ADDENDUM No. TWO

Project Name: Tri-Valley Trail, Phase 2
White Clay Creek State Park

Project No.: WCCSP-7A

Date of Issue: August 1, 2018

SIGNING PLAN

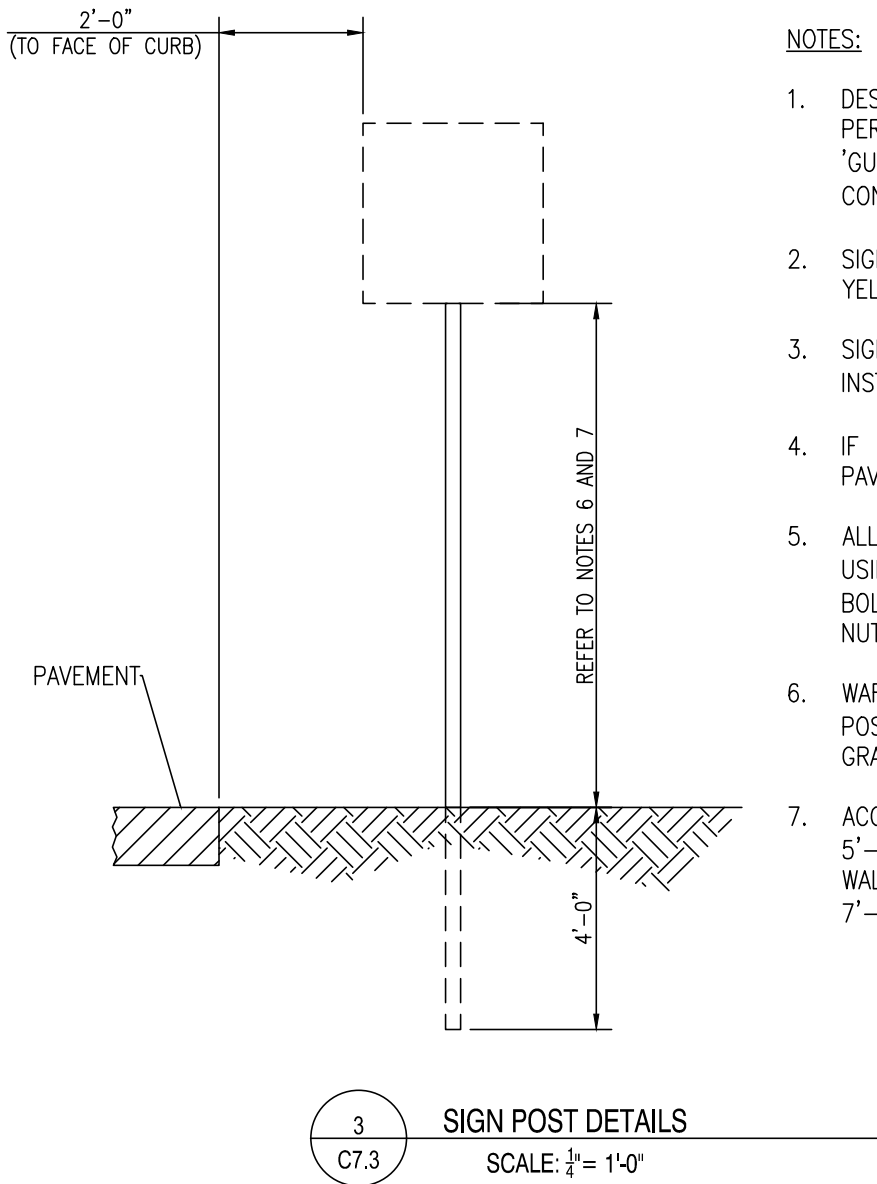
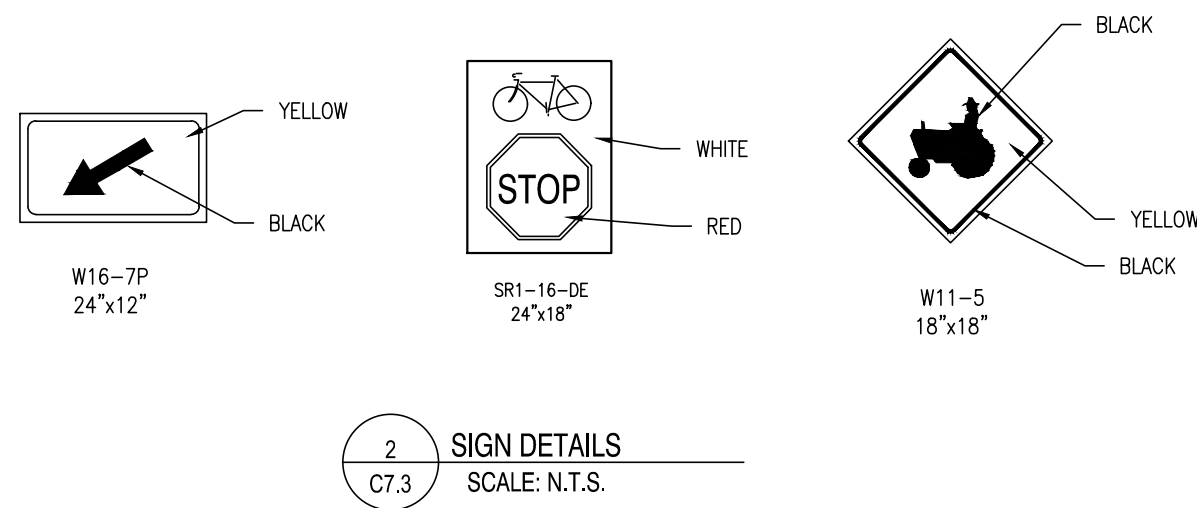
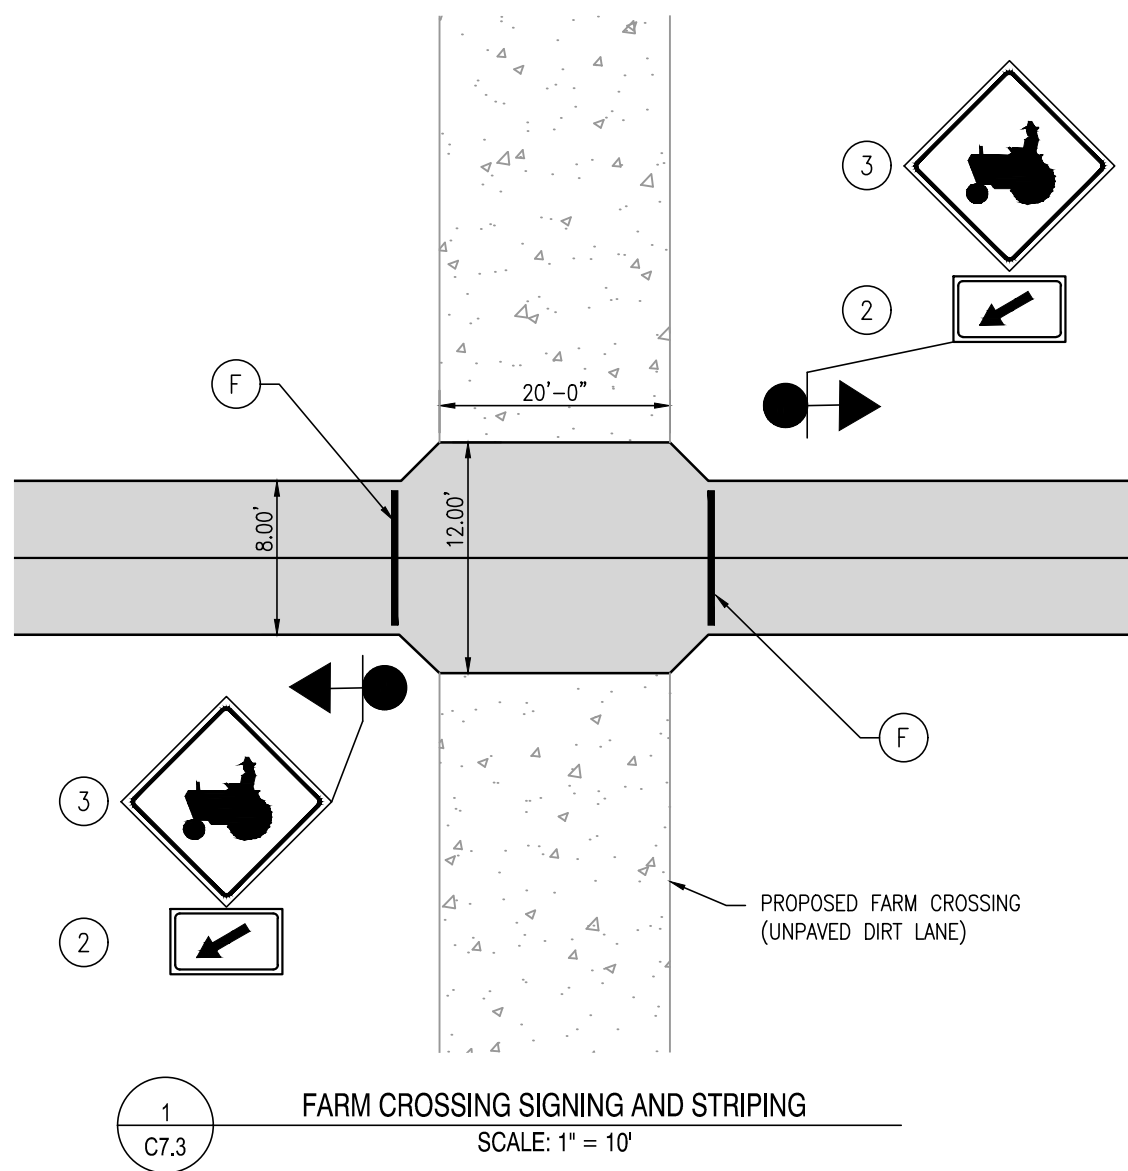
3. The following subcontractor categories are listed:
 - a. Signage and Striping: I only see one stop sign. Are there more signs and is there striping?
 - i. *The four proposed Farm Crossings shown on plansheet C1.2 are going to be signed and striped per the enclosed Signing Plansheet C7.3 by the contractor as a part of the base price.*

Drawings: Plansheet C7.3, the signage and striping plan for the farm crossings is enclosed for your use.
